AL BASRAH OIL TERMINAL  
BASRAH, IRAQ

**SIGIR PA-06-080**  
**APRIL 26, 2007**

SUBJECT: Report on the Al Basrah Oil Terminal, Basrah, Iraq (Report Number  
SIGIR PA-06-090)

## Al Basrah Oil Terminal, Basrah, Iraq

Figure 15. Illustration of a fully inflated life raft (note life raft does not appear to hold 20 occupants)

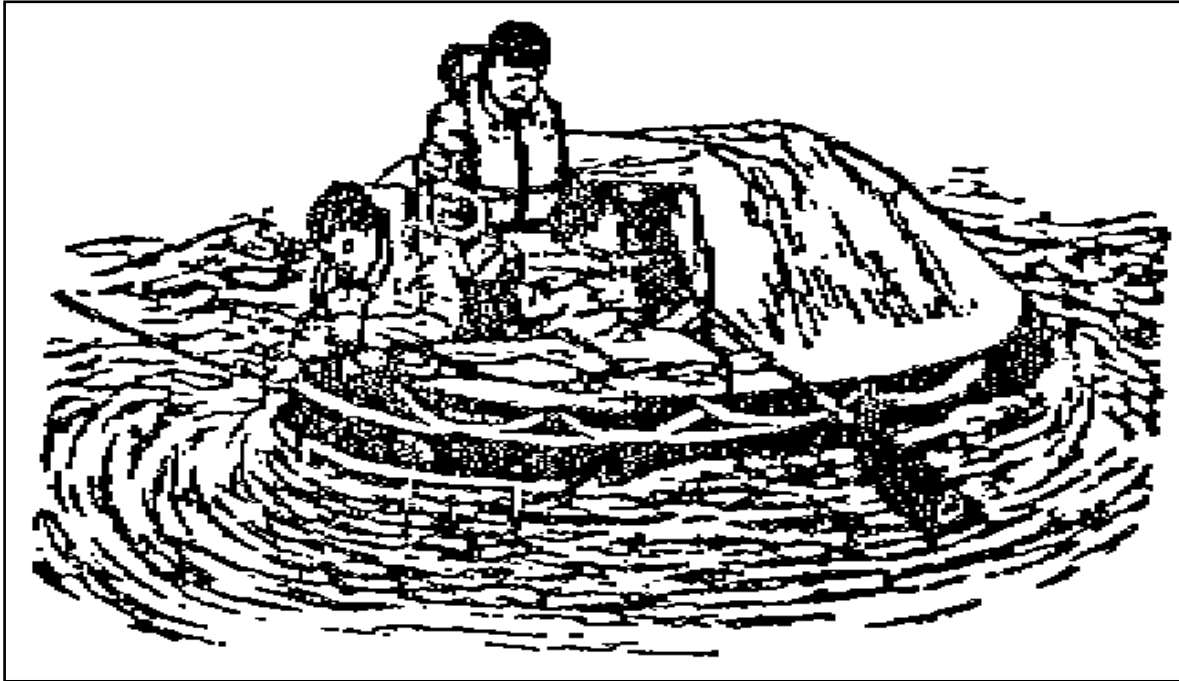
The information provided by the manufacturer did not include a photograph of the entire life raft, instead relying solely upon an illustration (Figure 15). The only photographs available of the life raft were provided by the company that inspected the life rafts. However, full length views of the front and rear of the life raft were not provided; instead only various angles of the life raft were available. Site Photos 22 and 23 provide an interior and exterior view of the life raft, respectively.

GRD representatives have stated the "the life rafts are totally enclosed," which complies with PIJV's specification that the "life raft shall have a canopy to protect the occupants from exposure..." The life raft chosen is not completely enclosed (Site Photos 24 and 25) and will not provide the occupants any protection from a major fire. In addition, GRD representatives stated that the life rafts are a "covered type design that would protect life raft from waves during heavy seas." According to GRD representatives, sea waves of approximately 15 feet are not uncommon for the ABOT area. We have concerns that this particular life raft, which is not fully enclosed and made of a soft skin cover, would survive long in such sea conditions.

Site Photo 22. Interior of life raft

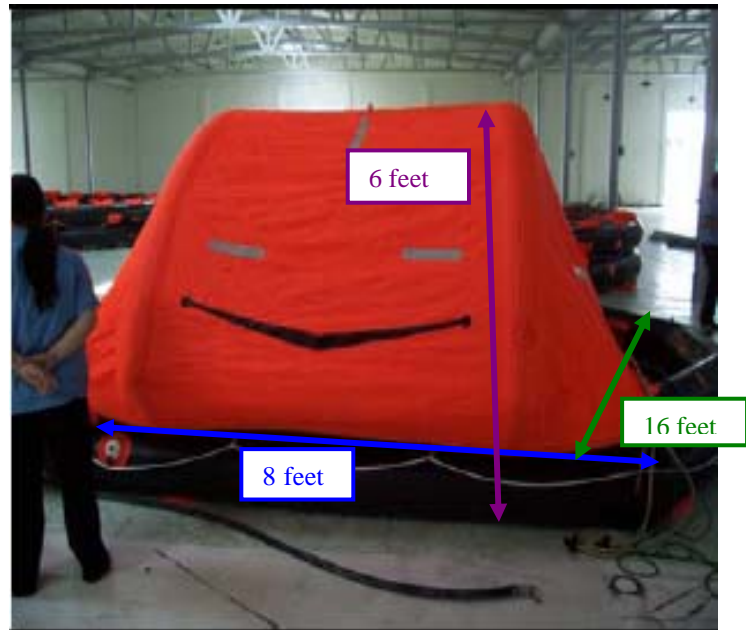
However, neither the Technical Inspection nor the manufacturer’s documentation addressed the issue of the maximum cumulative amount of weight of 20 people or the issue of the buoyancy of the life raft with 20 people on board. Without this information, it is questionable how the manufacturer determined each life raft has a carrying capacity of 20 people. GRD representatives, when asked these questions, stated that “GRD does not know if such tests were performed for this particular order placed by PIJV.” The manufacturer’s documentation indicated each life raft is approximately 16 feet in length, 8.5 feet wide, and the canopy is 6 feet high (Site Photo 23). This appears to be an extremely tight fit for 20 people.

Site Photo 26. Front and side viewing areas

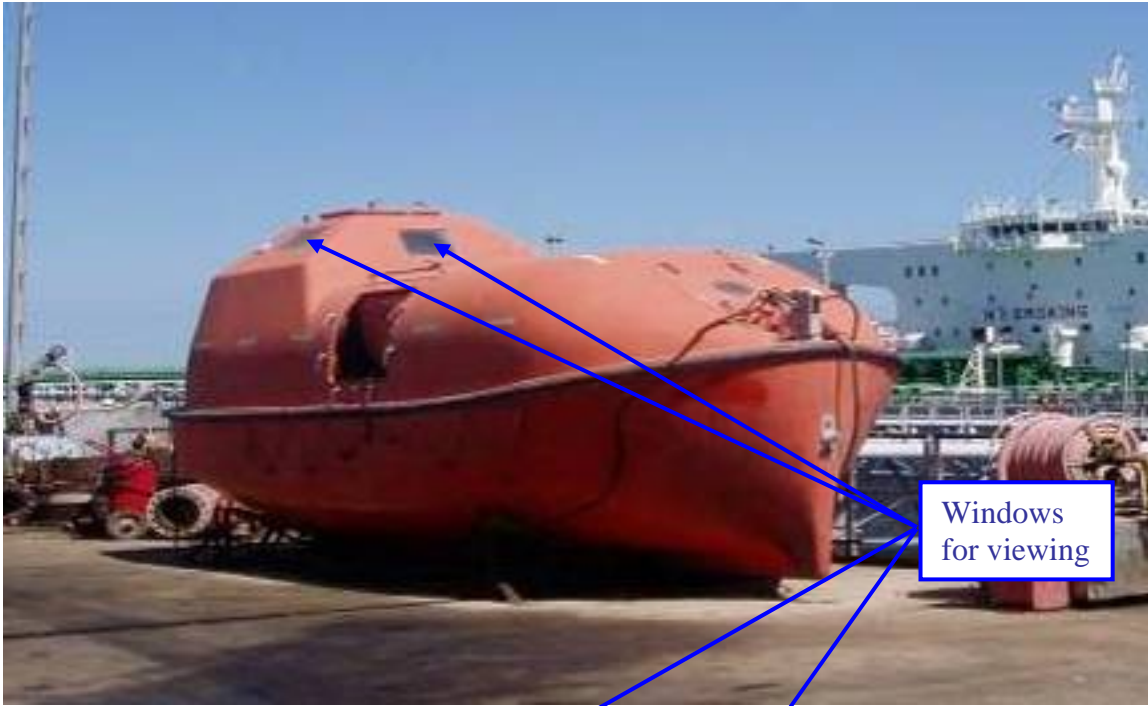
According to GRD Oil representatives, the standard for life raft is SOLAS and the life rafts procured comply with it; therefore, the life rafts are acceptable. However, this project was to provide "emergency and/or fast rescue boats" to be used in the "event of an emergency." The emergency described in PIJV's November 2005 PSSR was a "major fire." In the event of a major fire on the terminal, we believe the life rafts would not be an adequate means of escape. The existing escape capsules offer the best opportunity for survival not only because they are fully enclosed but they also provide front, rear, and side viewing to navigate through an ocean of burning oil (Site Photos 26 and 27).

**Figure 16. Current location of the two existing evacuation escape capsules and eight life rafts**

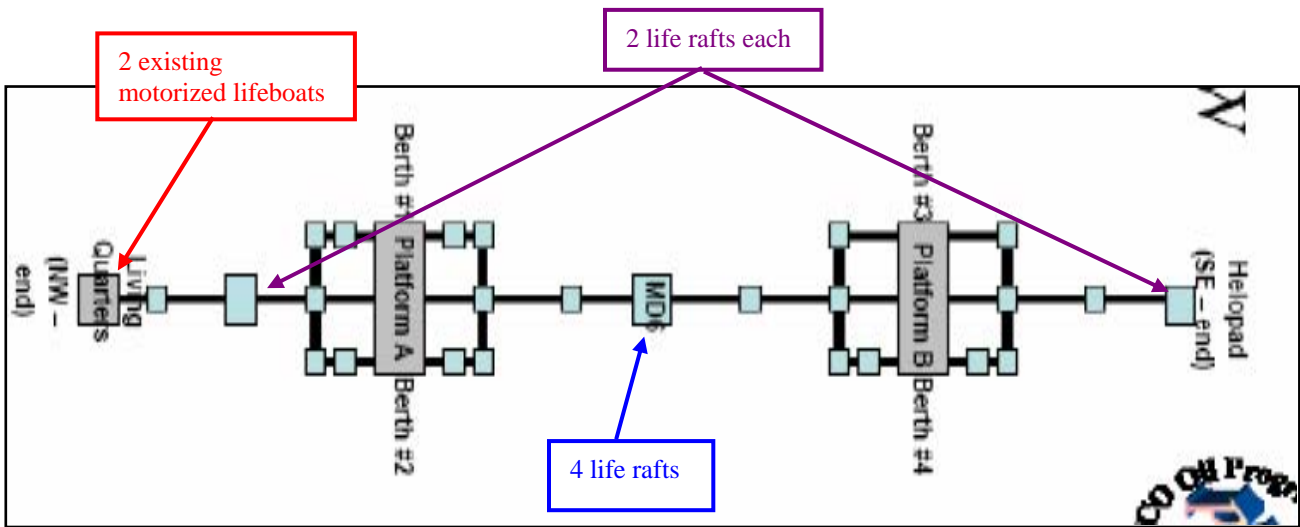
According to GRD representatives, the eight life rafts were installed at the helipad, MD6, and MD2 (Figure 16). Currently, there are no known muster points for an emergency evacuation on ABOT; therefore, we cannot determine if the life rafts were installed at the correct spots.
